SERVICE BULLETIN

No. 109

Date February 4, 1960

Subject: Addition Of Drain Holes, Concerning All Ercoupes, Aircoupes, and Fornaires Up To Serial #5714

FIG. 1.

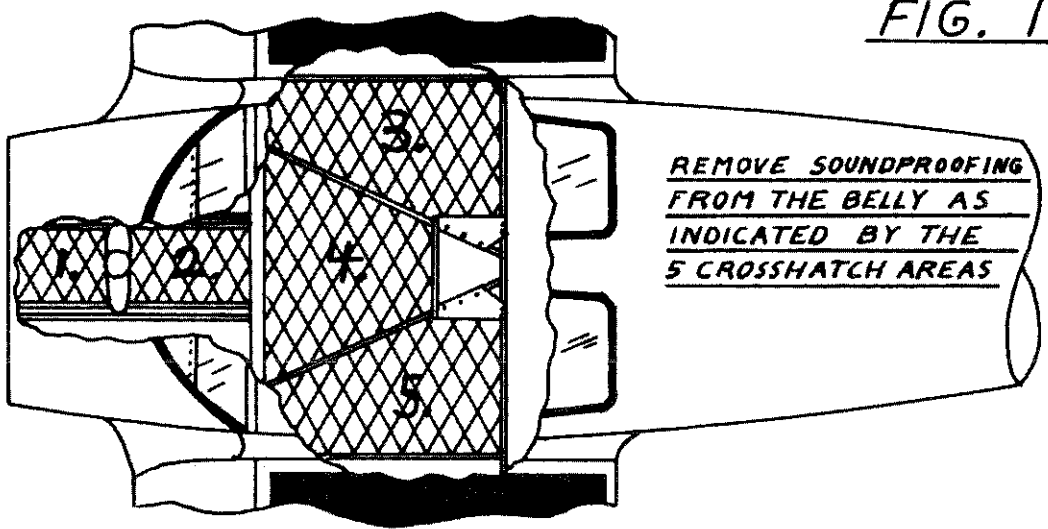
1. Forney modification kit (FMK) #27 is available which consists of four (4) clam shell cover plates to be used in conjunction with the added drain holes.
2. The procedure for modification is as follows:
 - a. Remove the forward floor board from the airplane.
 - b. Remove the seat cushion and unscrew the seat bucket from the front beam (two screws in the center top) and two screws attaching the bucket bottom to the diagonal ribs of the center section. The bucket can now be lifted up, rotating on the rearward hinge.
 - c. Remove (if present) all soundproofing in the lowest belly regions as shown in Fig. 1.

Note: Tests have been conducted and the result of increase noise upon removal of soundproofing in these areas is negligible. Therefore, do not replace the soundproofing. This will enable unobstructed drainage and prevent water from being held by absorption into the soundproofing.

FIG. 2.

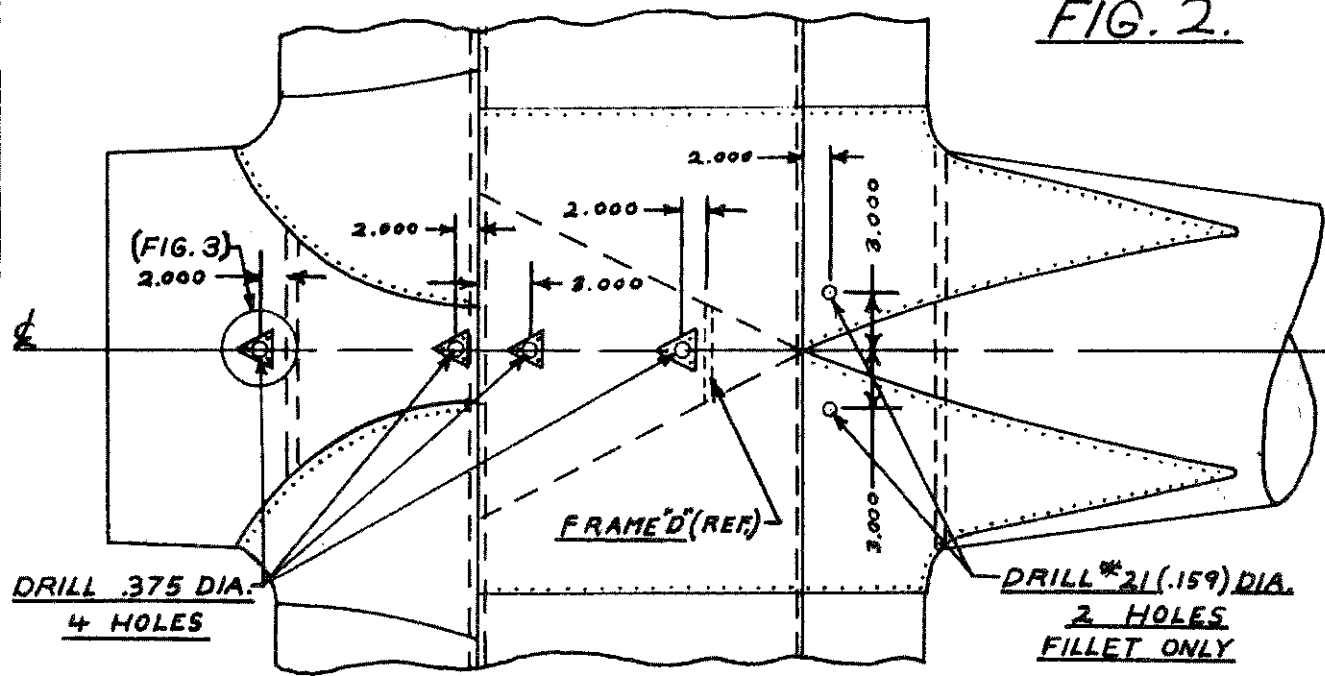
- d. Locate and drill six (6) drain holes as per Fig. #2.
- e. Install with AN-470AD3-3 rivets (alternative cherry rivets #CR163-4-3) four (4) clam shell cover plates as located per Fig. #2, and shown in detail per Fig. #3.
- f. Replace the seat bucket, cushion and forward floor board.
